**Board of Adjustment
Special Meeting Agenda
Fraser Town Hall, 153 Fraser Avenue
Wednesday February 26, 2025
5:30 PM - 6:30 PM**

4. Open Forum
5. Public Hearing
 - a. Appeal Of Administrative Variance Denial - The Ascent

RE: The Ascent – Final Plat, Major Site Plan, Administrative Variance
Planning Review Comments (1st Referral Review)

SITE PLAN
January 29, 2025
SHEET 2

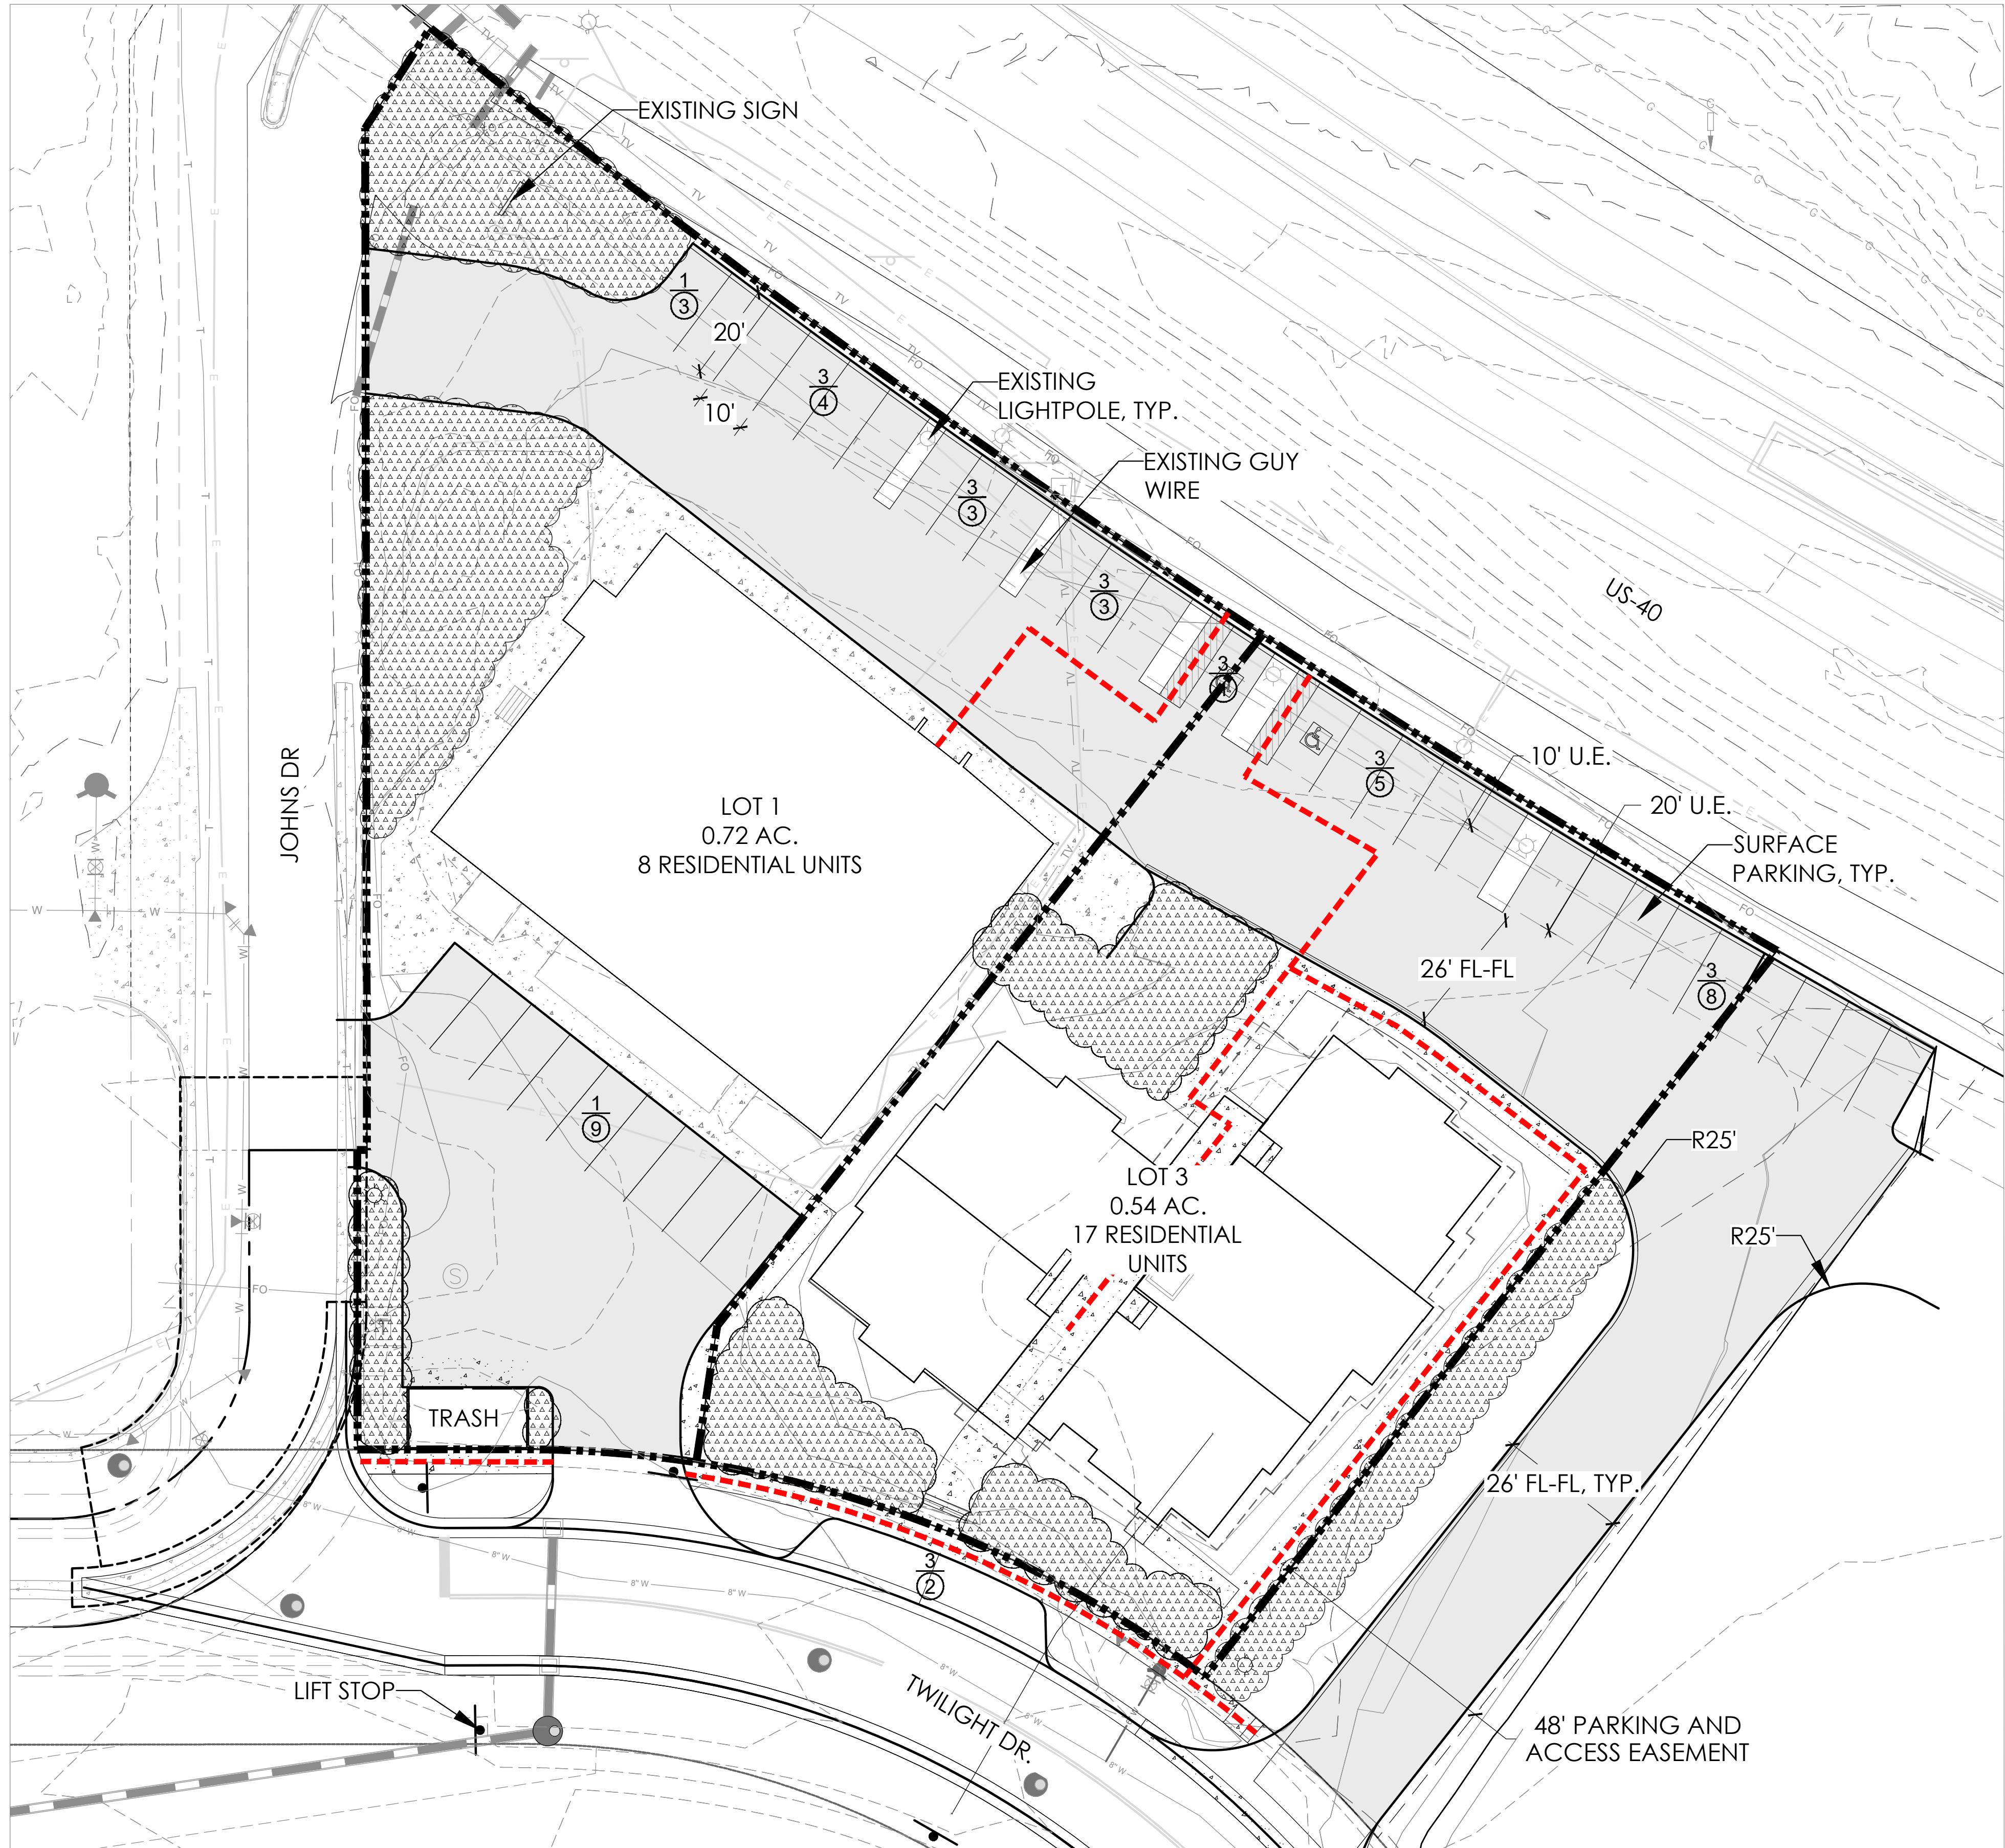
Sheet 2 – Site Plan

- 24) Provide a trash enclosure detail showing conformance with [Sec. 19-4-160\(b\)](#), i.e., label the enclosure color and materials to ensure they are consistent with those of the main building.

- 25) Include a summary of unit types by bedroom count or note that all units will be two-bedroom units.
- 26) Note or provide in the data table the number of bedrooms in the existing two units in the XSports building since there will be shared parking between the lots.

- 28) Please add a note that the two parallel spaces proposed along “Victory Rd” within the proposed ROW are included in the provided parking count.
- 29) Data table lists Lot 1A and 2B. Should be 1A and 1B unless the lots are renumbered to Lot 1 and Lot 3 as requested by staff.

LANDSCAPE PLAN
January 29, 2025
SHEET 3

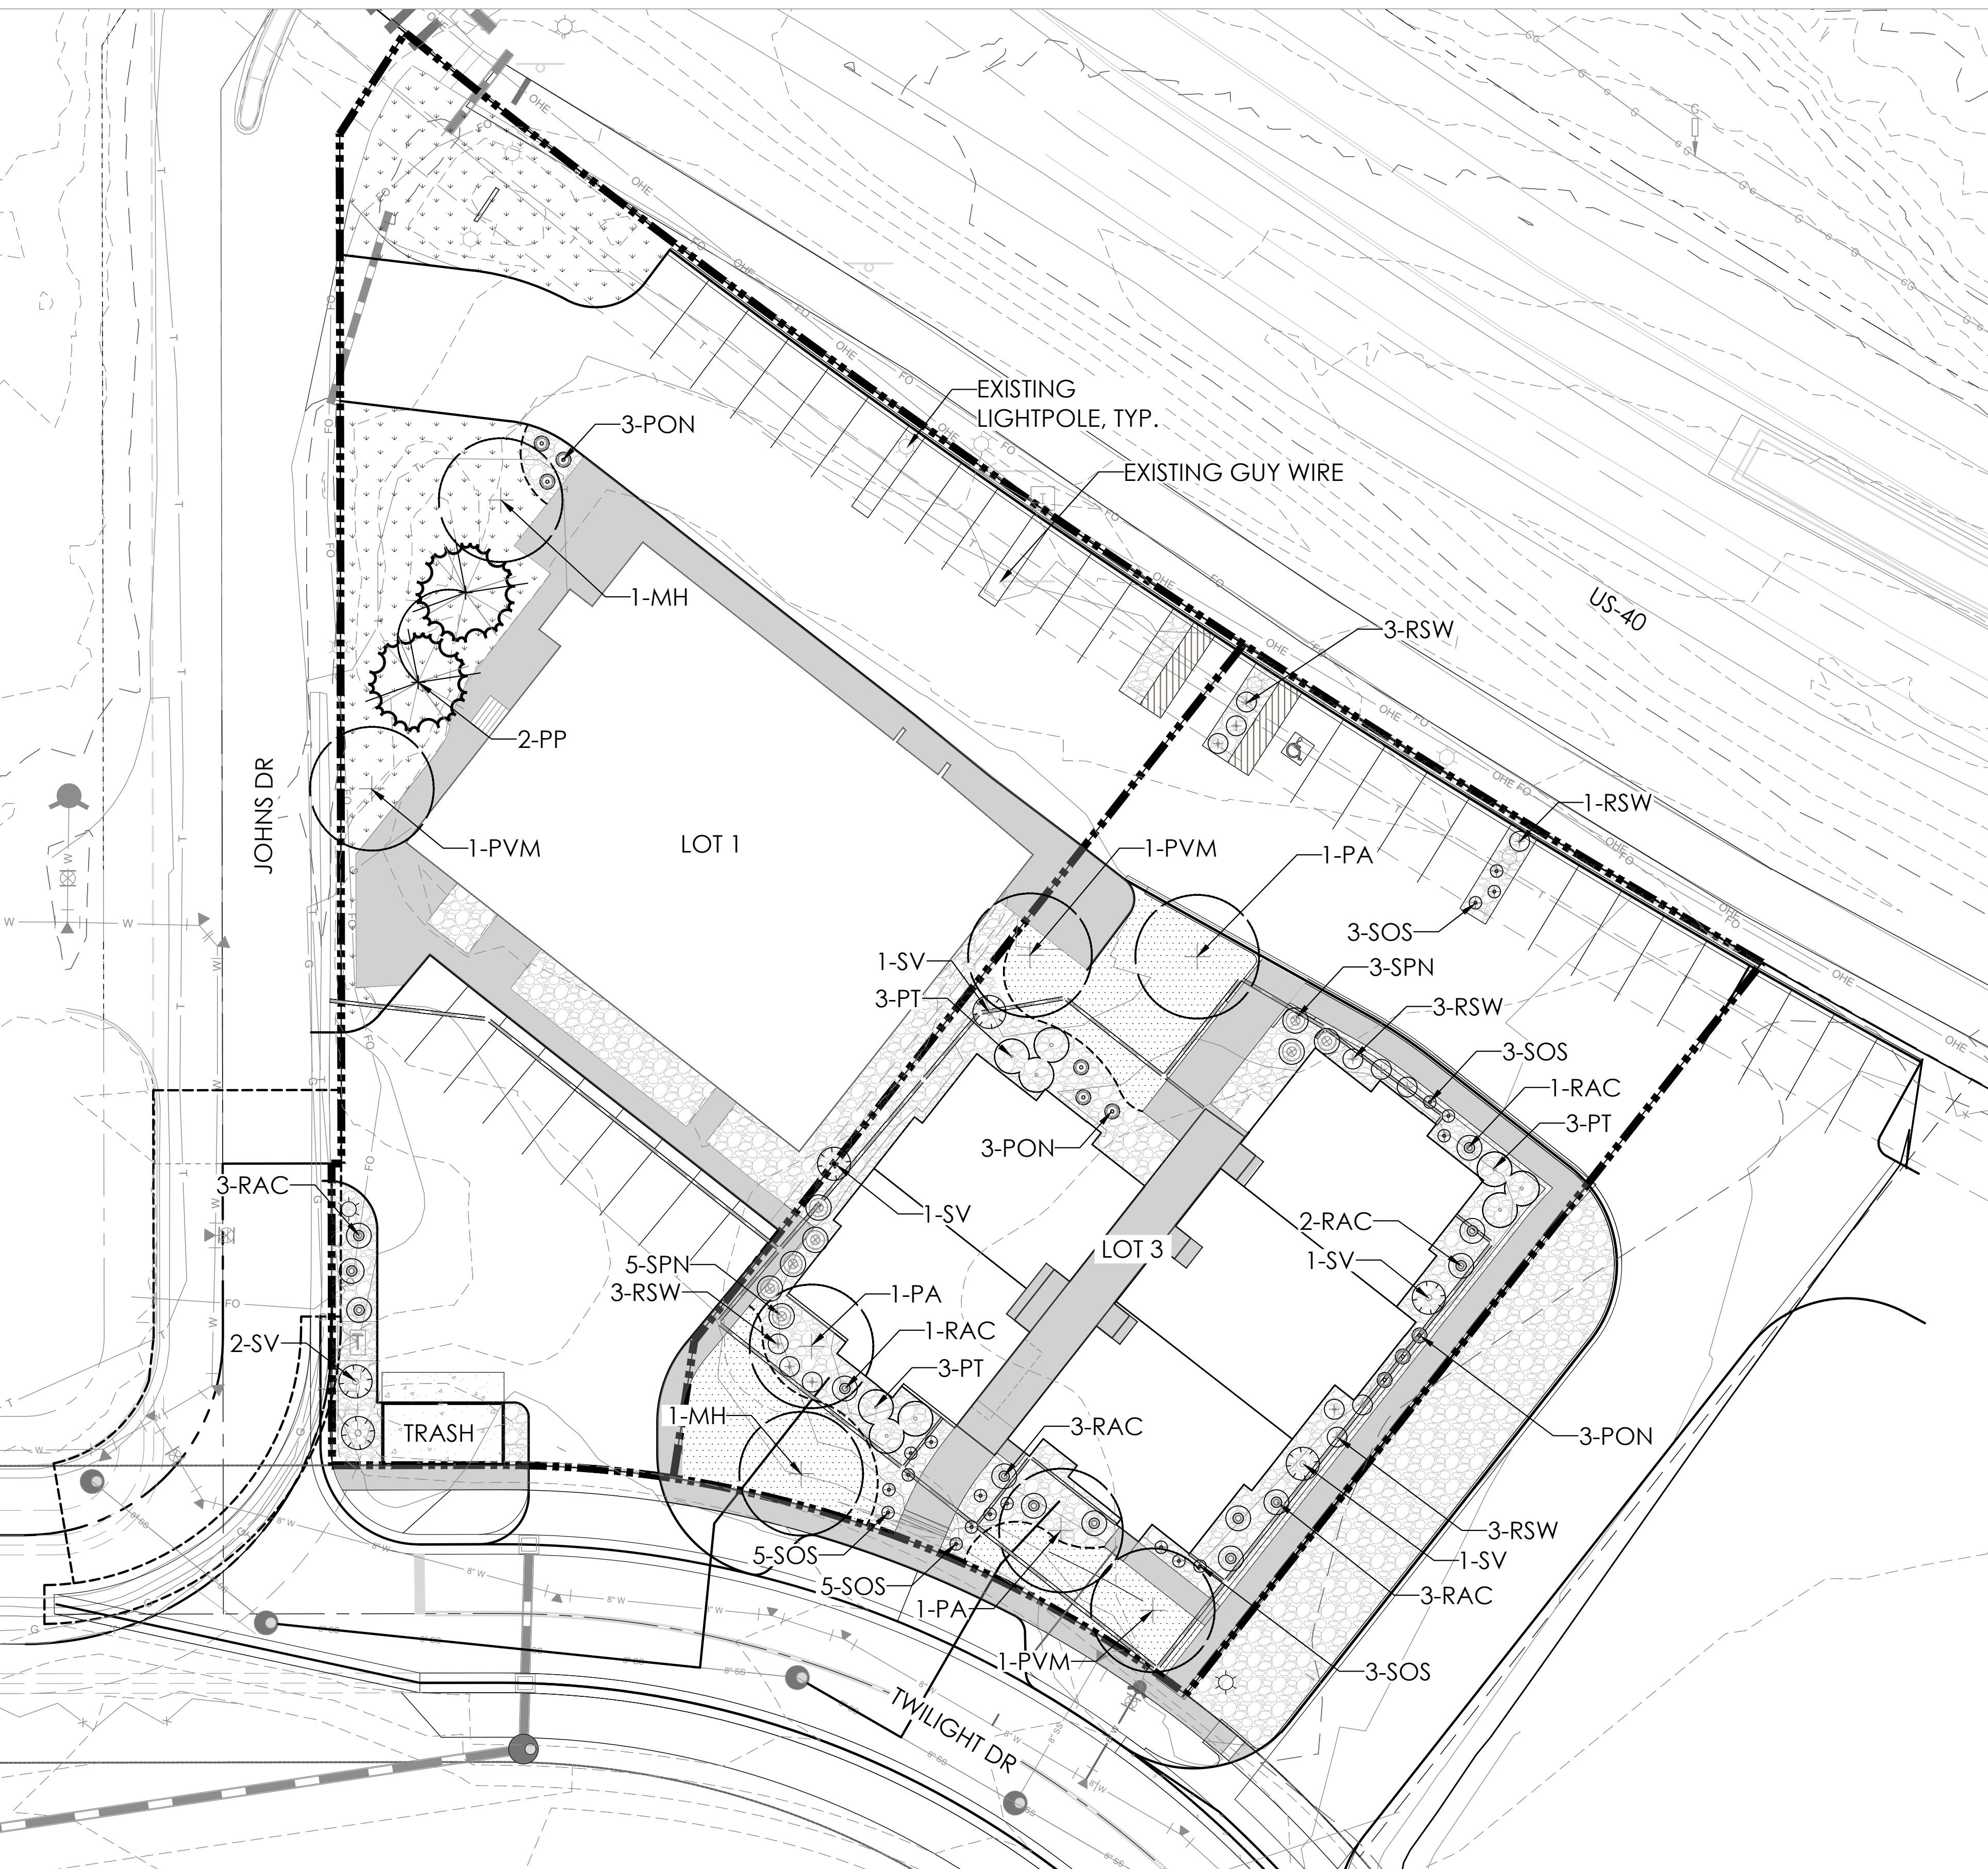
Sheet 3 – Landscape Plan

35) Provide the following as required in [Sec. 14-5-40](#) - landscaping specifications:
